PRODUCT CHANGE UPDATE

Subject: The MM14QP (EZ Mop 360) has 14 new improvements.

All MM14QP EZ Mops, starting with serial number D40ML7605 and following.
New versions started shipping on 02/27/2020 and thereafter.

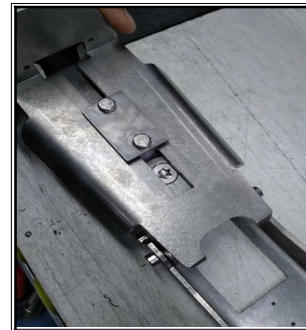
Improvement 1. New float system will be included in the recovery tank in order to turn off vacuum motor, when the tank is full. (Below)

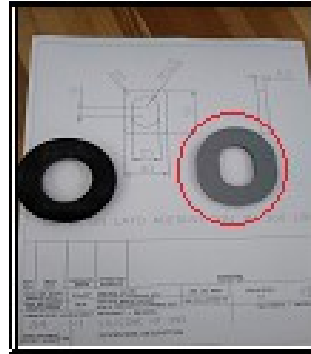
The squeegee will have an adjustable back wheel. (Picture on right)
